**COUNTY OF SAN MATEO
PLANNING AND BUILDING DEPARTMENT**

SUBJECT: EXECUTIVE SUMMARY: Consideration of the adoption of an Initial Study/Mitigated Negative Declaration, pursuant to the California Environmental Quality Act (CEQA), and an After-the-Fact Planned Agricultural District (PAD) Permit, pursuant to Section 6350 of the San Mateo Zoning Regulations, to legalize a 1,659 sq. ft., cargo container storage building, a man-made pond, and installation of a water tank and generator, on a legal 25,253 sq. ft. parcel located at 350 Madera Lane in the unincorporated San Gregorio area of San Mateo County. The property is located in the La Honda Road County Scenic Corridor.

County File Number: PLN2023-00112 (Markegard)

Figure 1 Proposed front of the revised building facing Madera Lane

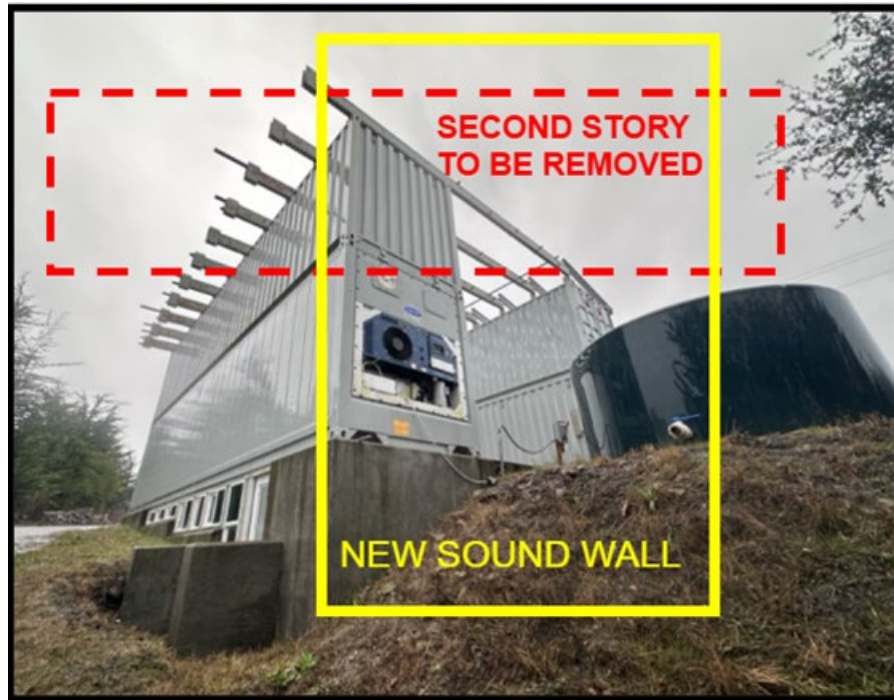
- The existing second story of the storage building shall be removed.
- The height of the first story of the container building with the new roof shall not exceed 20 feet from the existing grade.

- A new sound attenuating screening wall shall be installed in front of the freezer unit maintaining a front setback of at least 30 feet and 20 feet towards side and rear. The design of and materials used for this wall shall be subject to the review and approval of the Director of Planning and Building to ensure it will not result in adverse visual resource impacts.

Figure 2 Proposed side of the revised building facing La Honda Road

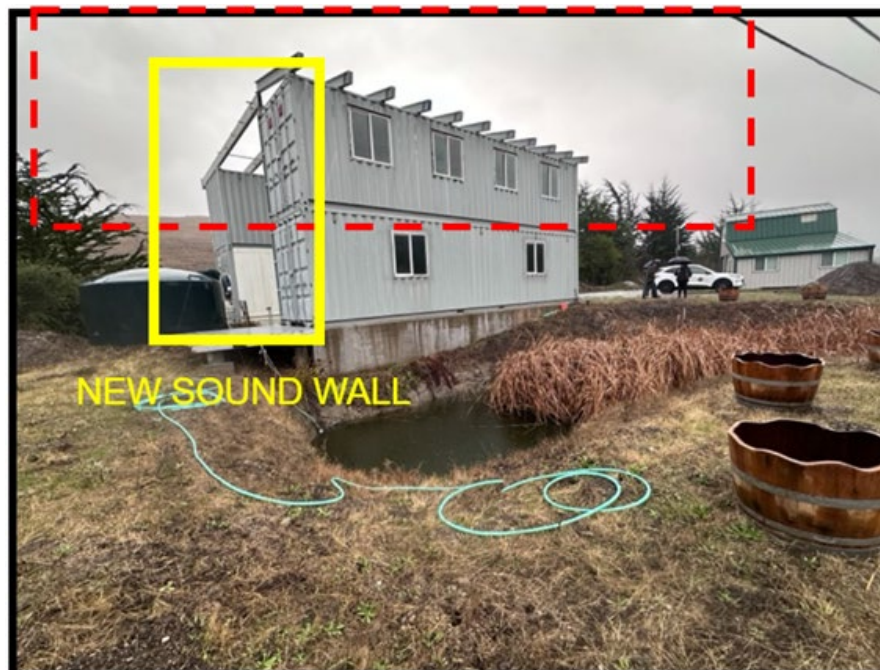
- Plant at least four to five screening trees with a minimum stock size of 15-gallon or larger along La Honda Road to mitigate any potential view impacts from the neighboring properties and roads.
- The plan submitted for building permit shall show installation of a new roof on the single-story portion of the building, to be painted green to match the roof color of the existing barn.
- The applicant shall obtain all necessary permits from PG&E and Caltrans for relocating any utility pole(s) from the site, etc.

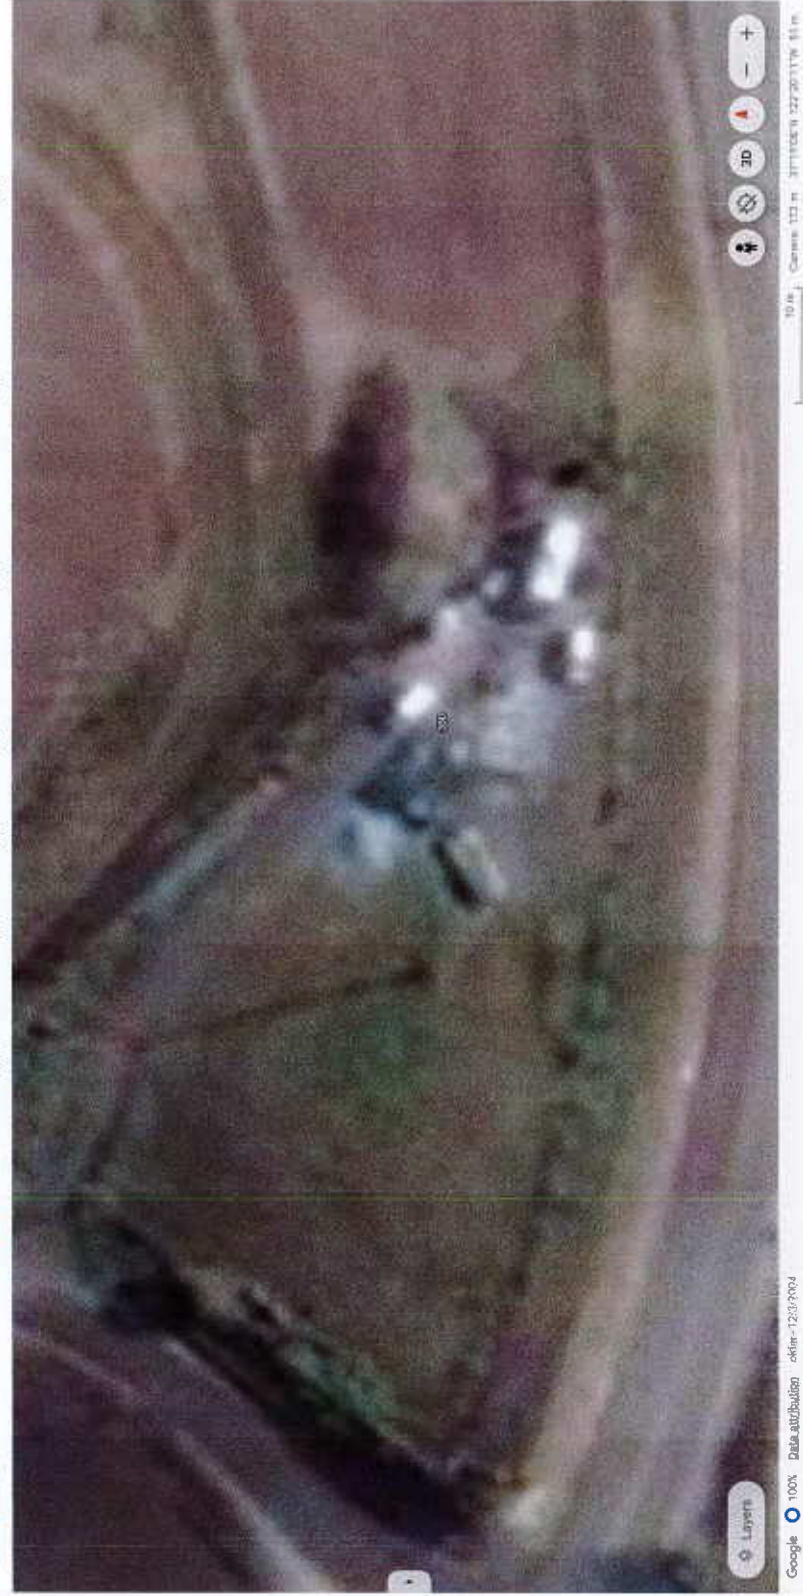
Shipping container apartment was for the future if the county ever changed their mind.

Even if the county did change their mind. The property will never get bigger to accommodate a proper septic system or provide potable water. Always intended to be a rental for income.

Attachment 7

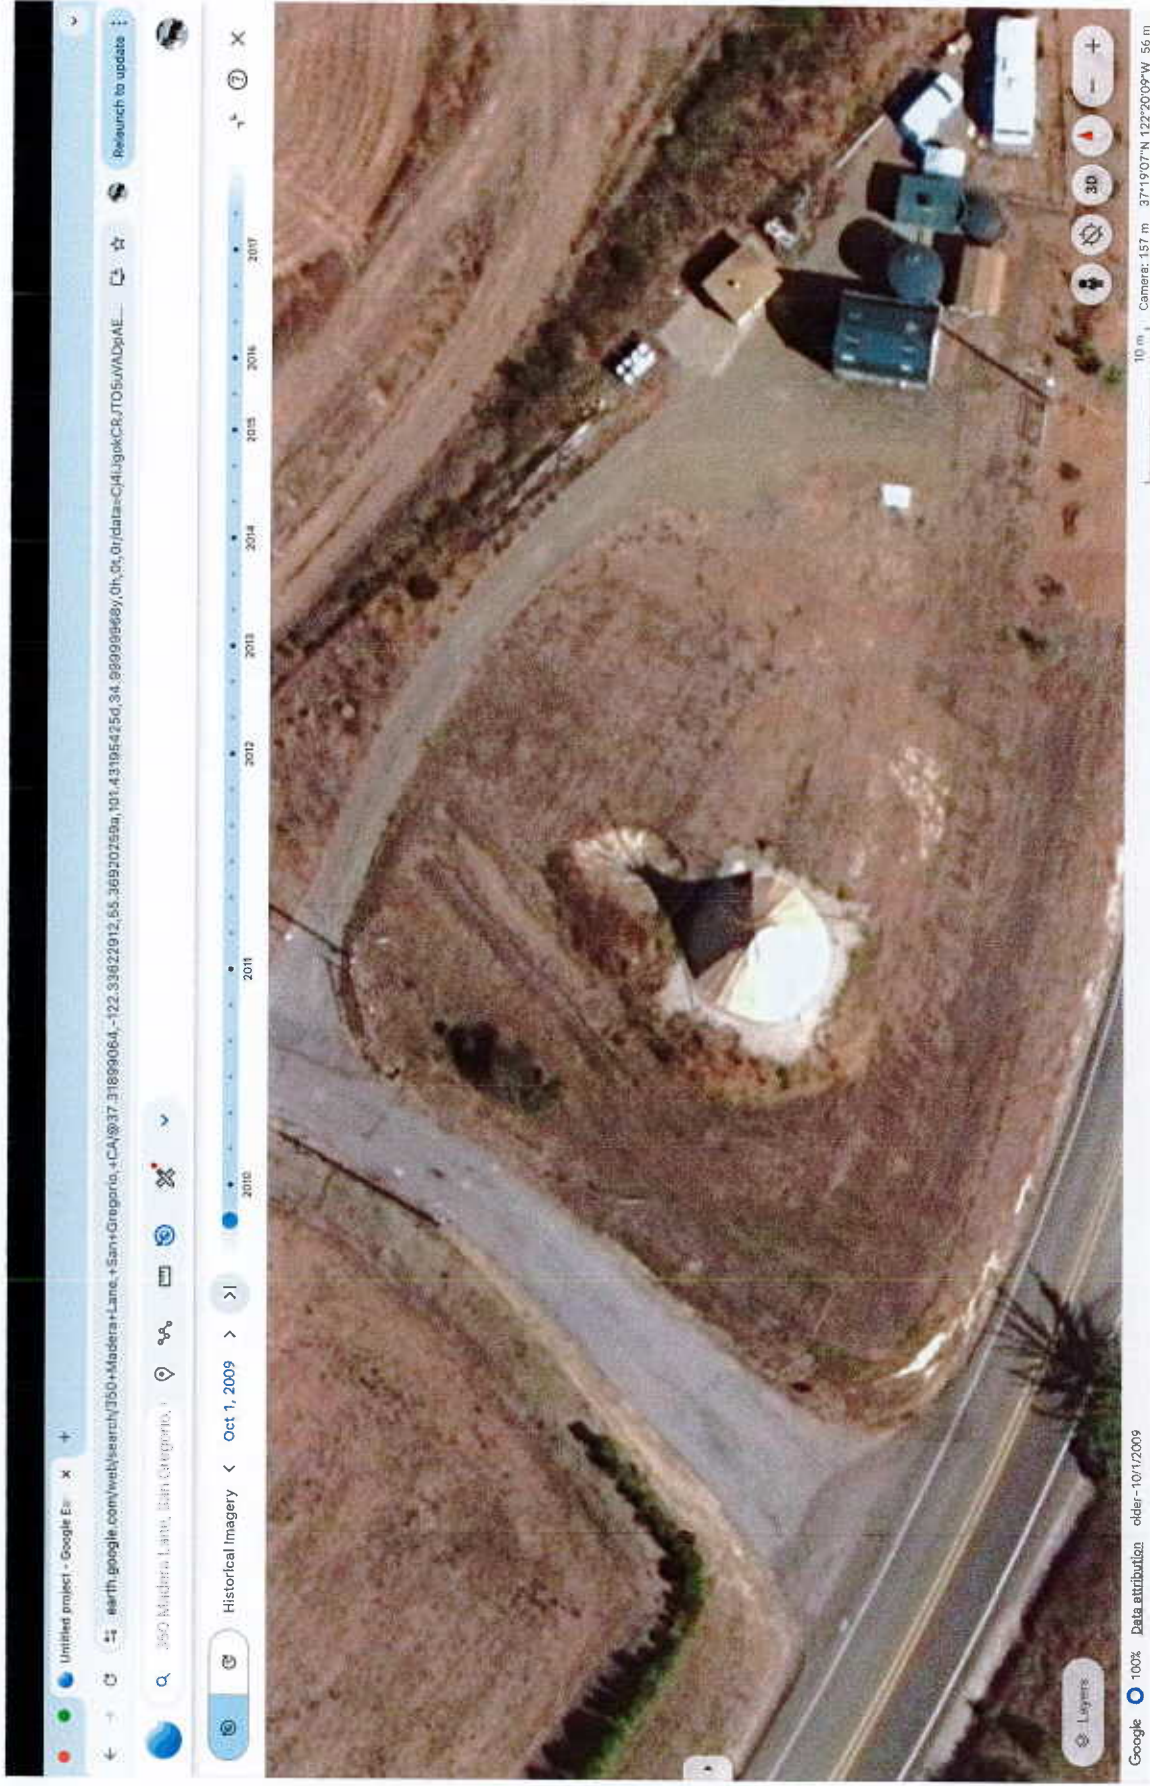
See attachments 7 & 8 of original placement and current. It was leaked to us that a friend of the applicant, Jason Cissell moved the pole for the applicant as a favor.
